ARCHITECTURAL REVIEW BOARD STAFF REPORT

Project #/Name	ARB-2024-71: 400 Rio Rd. West Outdoor Storage, Display, and Sales
Review Type	Conceptual Plan
Parcel Identification	04500-00-00-025C0, 04500-00-00-025C1
Location	400 Rio Road West
Zoned	Light Industrial (LI) / Entrance Corridor (EC) / Airport Impact Area (AIA)
Owner/Applicant	Virginia Telephone & Telegraph Co / Williams Mullen (Valerie Long)
Magisterial District	Rio
Context	Most of 45-25C is paved. Additional paving is adjacent on 45-25C1. Chain link fence encloses much of the paved area. The property contains two structures, a brick-faced office building at the front of the site along Rio Rd. and a large metal shed towards the rear of the paved area. The rear portion of 45-25C1 is wooded. To the south across Rio Rd. and separated from it by a solid wood screening fence is the Four Seasons residential development. Additional single-family detached homes are to the east. To the west is a light industrial parcel housing an HVAC company. (See Fig. 1.)

Figure 2: Proposed concept plan showing the buildings, travelways, outdoor storage, and parking.

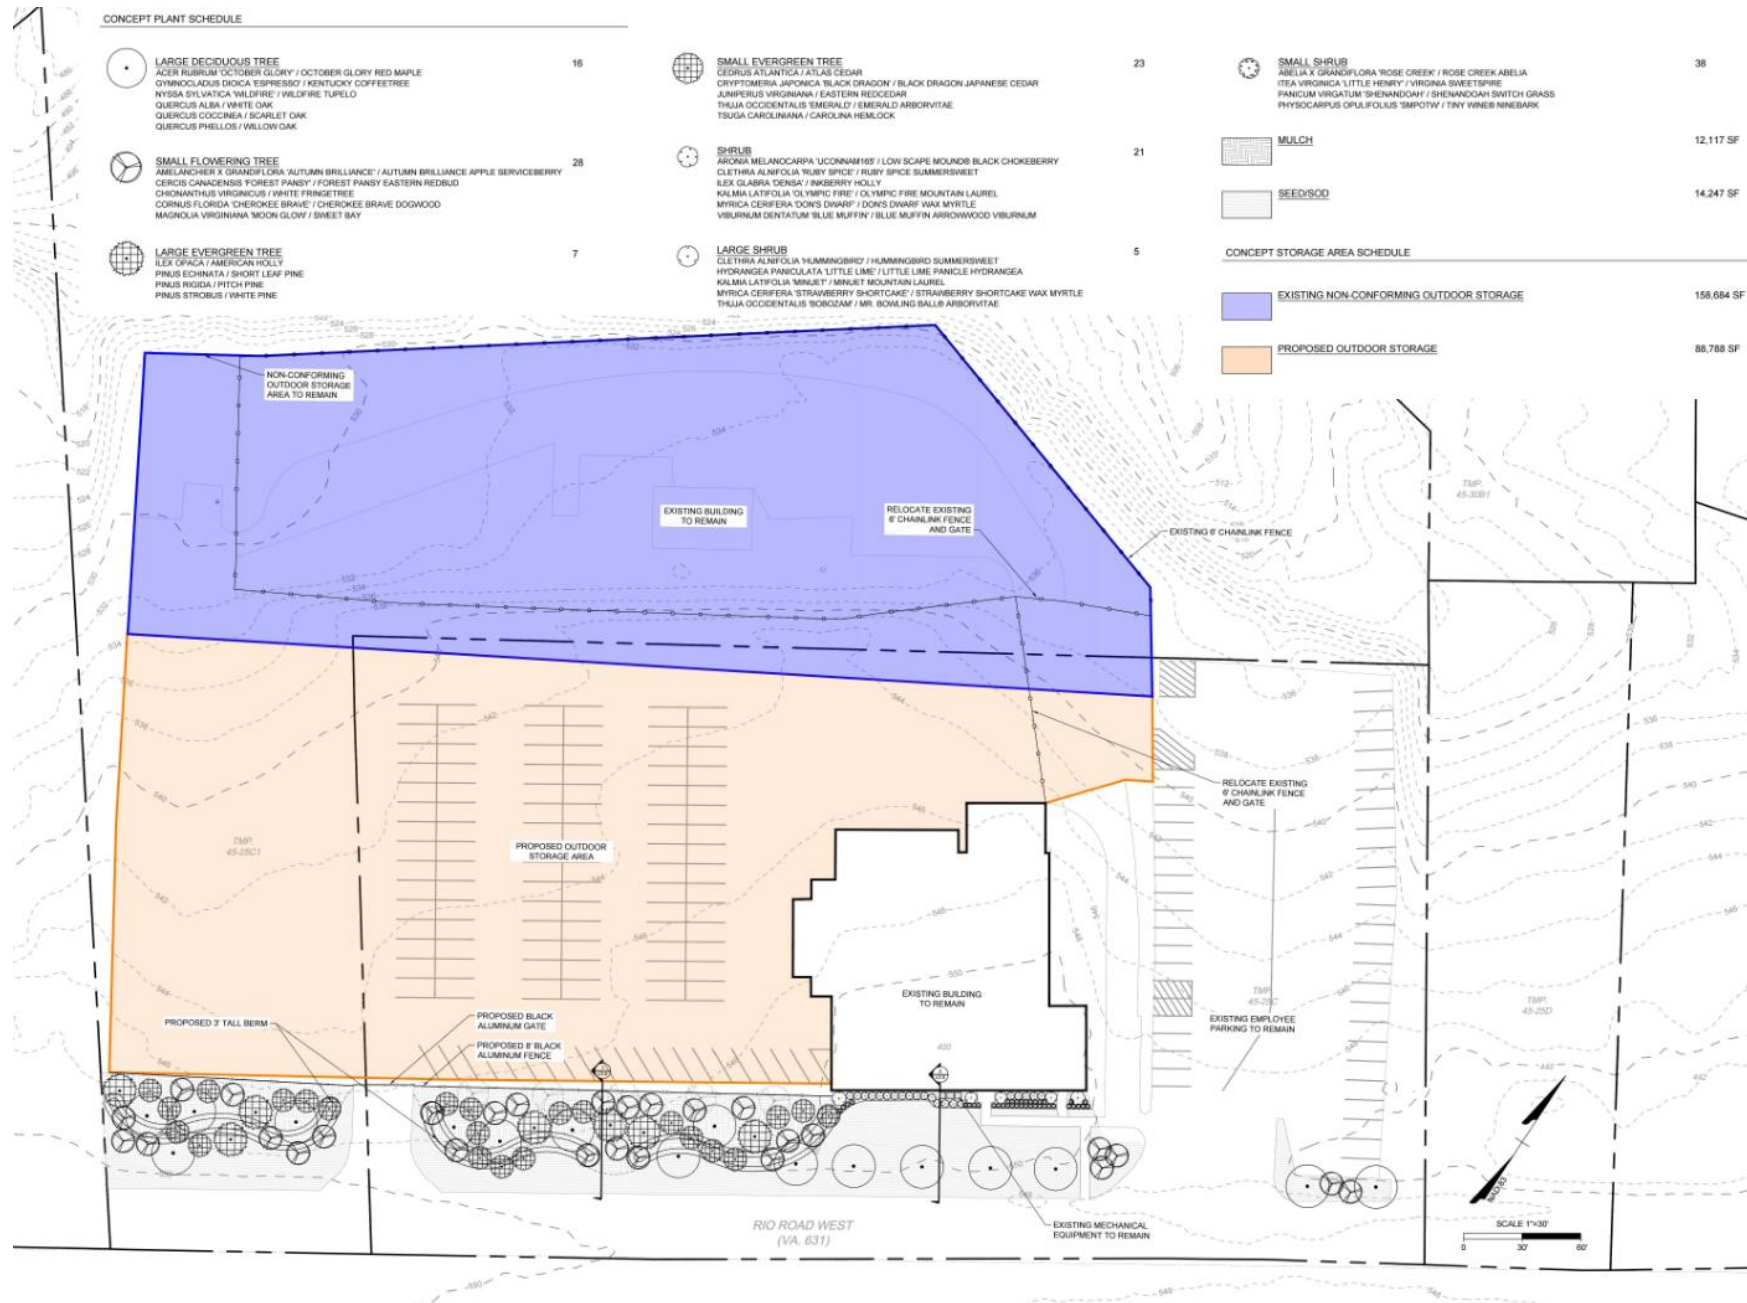
19	Screening devices should be compatible with the design of the buildings and surrounding natural vegetation and may consist of: a. Walls, b. Plantings, and c. Fencing.	  Fig. 3: Image of security fencing provided in the concept plan. To increase the screening of stored items, the applicant proposes to establish a 3-foot-tall berm along the new fence, with a mix of evergreen and deciduous plants on the berm. The planting arrangement shown exceeds the minimum requirements; however, the plants would not completely screen the storage area

when the use commences, and the western site entrance from Rio Rd. would create a permanent gap in the screening. Although the picket fence and landscaped berm will not completely screen the storage area from the EC, eliminating chain link fencing would have a positive impact, the aluminum fence would help establish an organized appearance, and the mix of plants on the berm would enhance the current frontage condition and better integrate the site into the surroundings, resulting in a more orderly and visually appealing development on the corridor. One of the site sections notes maximum storage height as 12’ and shows material storage (a pipe storage rack) that is the same height as the fence (8’) along the fence line. Exhibit D in the applicant’s narrative outlines the materials that will be stored at this location. The exhibits show a variety of materials distributed throughout the storage areas with no clear method of organization. Many of the items are stacked; some are not. Positioning items with lower overall stacked height closer to the EC, and taller items further from the fence line may help to minimize the negative visual impact on the EC. The ARB has typically required that storage/display/sales spaces for vehicles must be striped like standard parking spaces. This requirement allows for distribution and orientation that is more like standard parking lots. In this case, vehicles would not be stored but depending on the vehicle type and size parking them towards the front of the storage area may also help reduce the visual impact on the EC and provide for a more consistent and orderly appearance as viewed from the street. The concept plan shows a portion of the existing chain link fence to the east of the building relocated west, behind the building. Any portion of this relocated fencing visible from the EC would be subject to ARB review. The loading, service, and refuse areas have not been labeled on the concept plan. Siting these areas in locations where they will not be visible from the EC would be appropriate.

because common landscape features will help to harmonize the appearance of development as seen from the street upon which the Corridor is centered.	exceeds frontage landscaping requirements but details on planting size have not been provided. The plantings are also expected to increase the continuity along the EC; however, the landscaping would not provide complete screening of the materials and storage area when the use commences.	
32	Landscaping along the frontage of Entrance Corridor streets should include the following: a. Large shade trees should be planted parallel to the Entrance Corridor Street. Such trees should be at least 3½ inches caliper (measured 6 inches above the ground) and should be of a plant species common to the area. Such trees should be located at least every 35 feet on center. b. Flowering ornamental trees of a species common to the area should be interspersed among the trees required by the preceding paragraph. The ornamental trees need not alternate one for one with the large shade trees. They may be planted among the large shade trees in a less regular spacing pattern. c. In situations where appropriate, a three or four-board fence or low stone wall, typical of the area, should align the frontage of the Entrance Corridor street. d. An area of sufficient width to accommodate the foregoing plantings and fencing should be reserved parallel to the Entrance Corridor street, and exclusive of road right-of-way and utility easements.

33	Landscaping along interior roads: a. Large trees should be planted parallel to all interior roads. Such trees should be at least 2½ inches caliper (measured six inches above the ground) and should be of a plant species common to the area. Such trees should be located at least every 40 feet on center.	There are no interior roads within this site.	None.
35	Landscaping of parking areas: a. Large trees should align the perimeter of parking areas, located 40 feet on center. Trees should be planted in the interior of parking areas at the rate of one tree for every 10 parking spaces provided and should be evenly distributed throughout the interior of the parking area. b. Trees required by the preceding paragraph should measure 2½ inches caliper (measured six inches above the ground); should be evenly spaced; and should be of a species common to the area. Such trees should be planted in planters or medians sufficiently large to maintain the health of the tree and shall be protected by curbing. c. Shrubs should be provided as necessary to minimize the parking area's impact on Entrance Corridor streets. Shrubs should measure 24 inches in height.	The existing parking lot on the east side of the parcel would remain. The area south of the lot serves as the parking lot perimeter and street frontage. In this area, the concept plan shows plantings that could meet the frontage landscaping requirements. Along the east side of the parking lot between the lot and parcel boundary is existing vegetation but this is not shown on the concept plan. The existing employee parking lot does not meet the requirement for interior parking trees. Four large shade trees would be required based on the 42 parking spaces.	See recommendations provided with the Guidelines on site grading. Consider adding one interior parking lot tree for every ten parking spaces in the employee parking lot.

37	Plant species: a. Plant species required should be as approved by the Staff based upon but not limited to the <i>Generic Landscape Plan Recommended Species List</i> and <i>Native Plants for Virginia Landscapes (Appendix D)</i> .	A conceptual landscape plan has been provided with this submittal. The plant schedule provides example shrub species but some of the species shown are not on the approved plant list.	Provide a complete landscape plan with the site plan. Ensure that the proposed species are on the approved plant list.
38	Plant health: The following note should be added to the landscape plan: “All site plantings of trees and shrubs shall be allowed to reach, and be maintained at, mature height; the topping of trees is prohibited. Shrubs and trees shall be pruned minimally and only to support the overall health of the plant.”	The standard plant health note does not appear on the plan.	Include the standard plant health note on the landscape plan submitted with the site plan.

1. Revise the concept plan to provide a layout that shows how the proposed materials and equipment within the storage area will be organized.
2. Revise the concept plan to show that storage of materials and equipment taller than the fence height will be limited to the rear of the site.
3. Revise the concept plan to show that vegetation near the parcel's eastern and western boundaries will remain.
